Access Compliance Report Public Rights-of-Way (Curb Ramps)

Main Street: N/A Cross Street: LAMBERT_RD Location: N

ADA ID: RPRK220201122941 Ramp Type: Type 6 - Directional 1 Initial Pass/Fail: Pass Overall Compliance: No Severity Score: 10

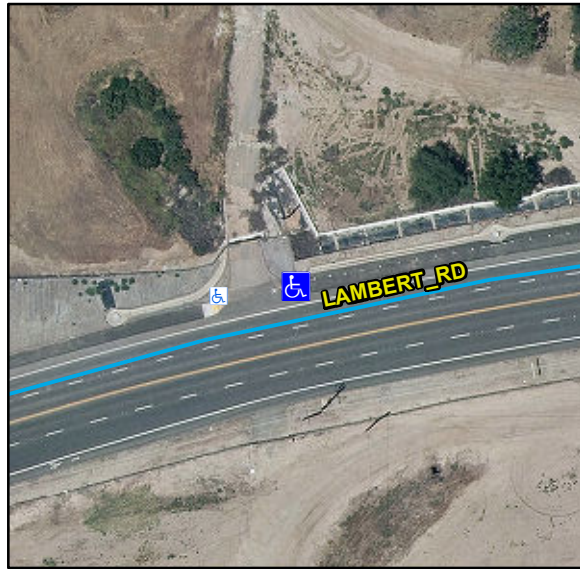
R304.2.1, R304.2.2-Perp, R304.3.2-Para, R304.5.3, R302.7, STD 1115

Compliance	Description	Data	Compliance	Description	Data
N/A	Ramp Length (in)	154	Yes	Flare Type LT	Curbed2
Yes	Ramp Width (in)	70			
Yes	Ramp Run Slope (%)	7.5	N/A	Flare Slope LT (%)	N/A
Yes	Ramp Cross Slope (%)	0.7	N/A	Flare Traversable LT	N/A
Yes	Grade Break	Yes	N/A	Flare Type RT	
Yes	Grade Break Slope (%)	1			Sloped
Yes	Grade Break Cross Slope (%)	0.2	Yes	Flare Slope RT (%)	6.8
	Addl Para Ramp Left?	No	N/A	Flare Traversable RT	Yes
	Addl Para Ramp Right?	No	Yes	DWS Provided	Yes
N/A	Landing Present	No	Yes	DWS Contrast	Yes
No	Landing Length (in)	N/A	Yes	DWS Length (in)	80
No	Landing Width (in)	N/A	Yes	DWS Full Width	Yes
No	Landing Run Slope (%)	N/A		DWS Offset Type	Single
No	Landing Cross Slope (%)	N/A	Yes	DWS Left Offset (in)	0
N/A	Landing Movement Obstructed?	No	N/A	DWS Right Offset (in)	0
	Landing Movement Type	N/A			
N/A	Landing Shared	N/A			
N/A	Marked Crosswalk 1	No	N/A	Clear Space	N/A
	Crossing 1 Direction	W	N/A	Clear Space To Crosswalk (in)	N/A

N/A	Marked Crosswalk 1 Width (in)	N/A			
N/A	Ramp Inside Crosswalk 1	N/A			
	Crossing 1 Slope (%)	14			
	Crossing 1 Cross Slope (%)	1.9			
No	Gutter Ponding	Yes	Yes	Curb Slope	5.2
Yes	Gutter Lip Height (in)	0		Road Run Slope (%)	N/A
Yes	Gutter Run Slope (%)	3.9		Road Cross Slope (%)	N/A
No	Gutter Cross Slope (%)	2.2		Parallel Ramp Side	Left
Yes	Overall Surface Condition	Acceptable	Yes	Perp Joint Present	Yes
	Cross Gutter Present?	No		Spandrel Present?	No
	Replace Cross Gutter?	N/A		Replace Spandrel?	N/A

Install Landing. Remove & Replace Gutter.
